**OPERATIONS SAFETY NOTICE**

**OSN 212-01-38  
OSN 412-01-24  
OSN 412CF-01-04**

**TO: All Owners/Operators of Bell 212/412/412CF Helicopters**  
**SUBJECT: ENGINE INTAKE FAIRING P/N 212-061-207-023 / -025, Inspection Of**

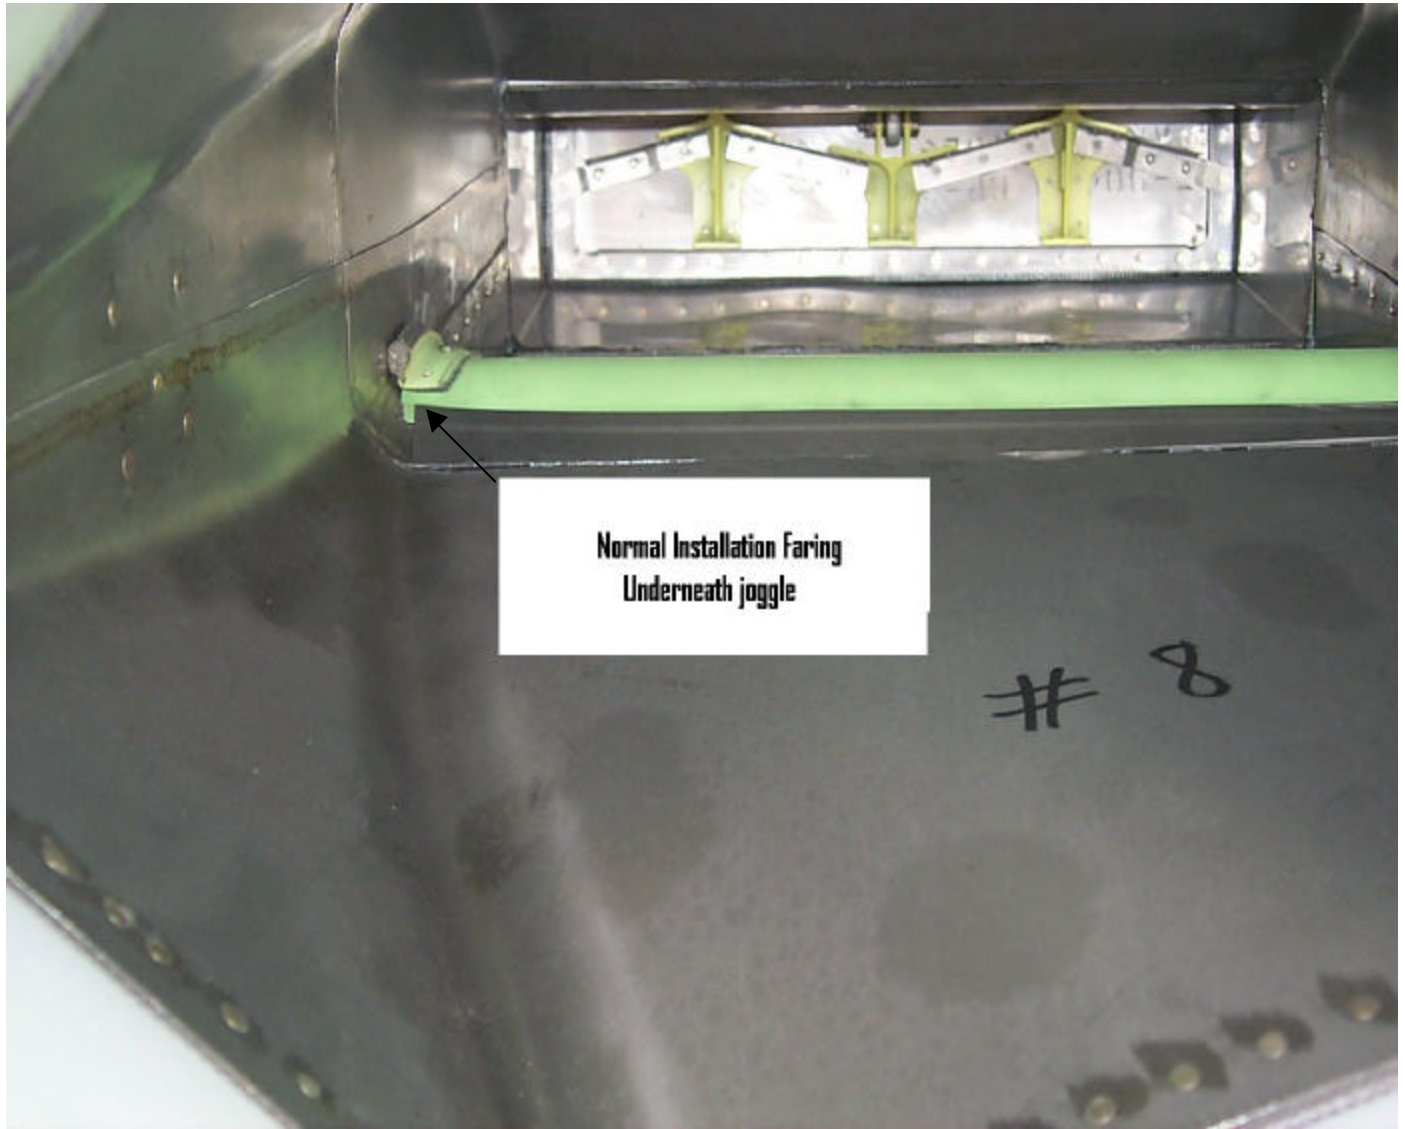
The P/N 212-061-207-023 / -025 fairing should be inspected to ensure the ramp (yellow portion) is positioned underneath the joggle at the forward end.

Replace detail parts as required if any cracks or deformations are observed on the ramp portion.
